**TESTIMONY OF PETER LEINENBACH, AQUATIC AND LANDSCAPE ECOLOGIST**  
**ENVIRONMENTAL PROTECTION AGENCY, REGION 10**  
**BEFORE THE OREGON BOARD OF FORESTRY, July 23, 2015**

**Figure 1a. Observed mean stream shade response associated with “no-cut” riparian buffers with adjacent clearcut harvest.**

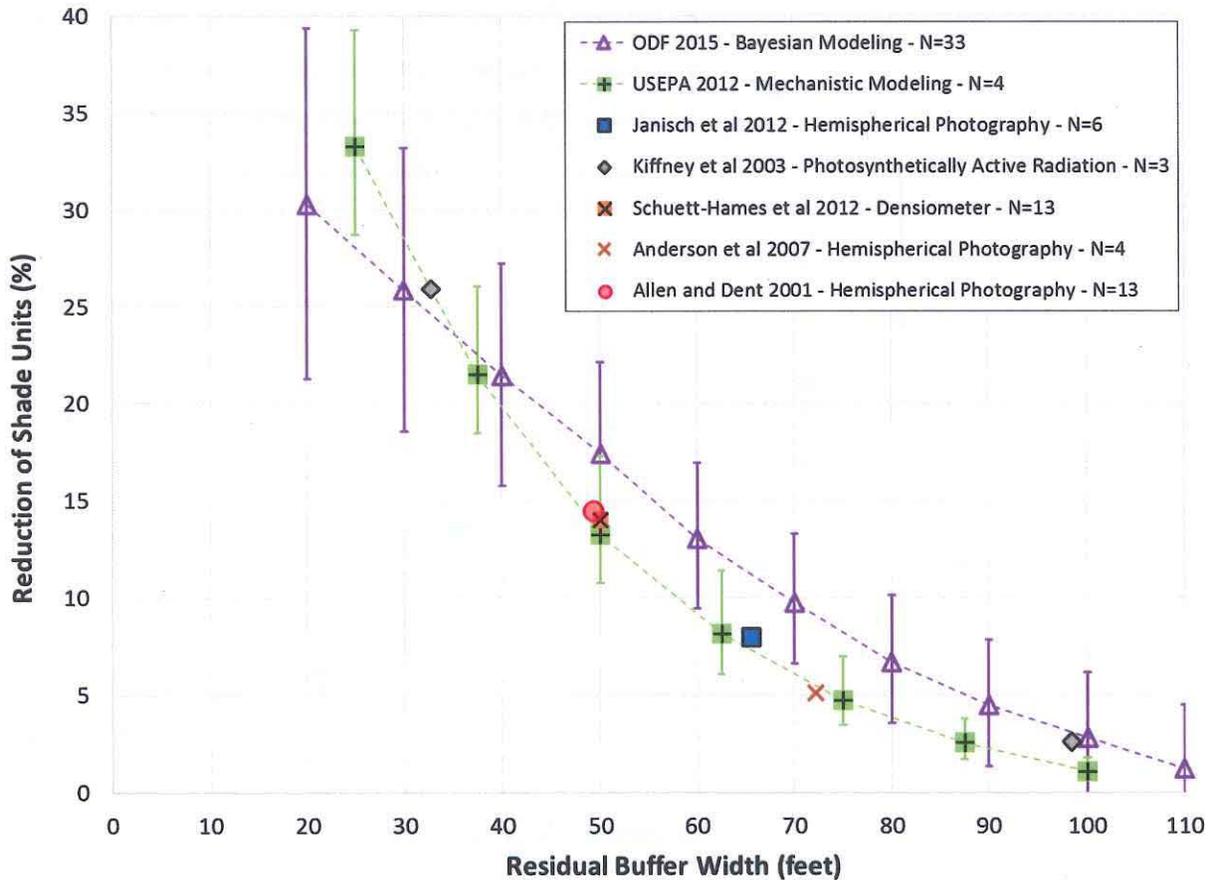
The **first point** is that the ODF staff have presented strong evidence through the Ripstream analysis that **a minimum of a 90 foot intact “no-harvest” riparian buffer** is needed to ensure that streams exposed to FPA rules do not violate the PCW rule. It is important to point out that this finding is supported by other research on this subject that has been done in the Pacific Northwest over the past several decades (**Figures 1a. and 1b.**).
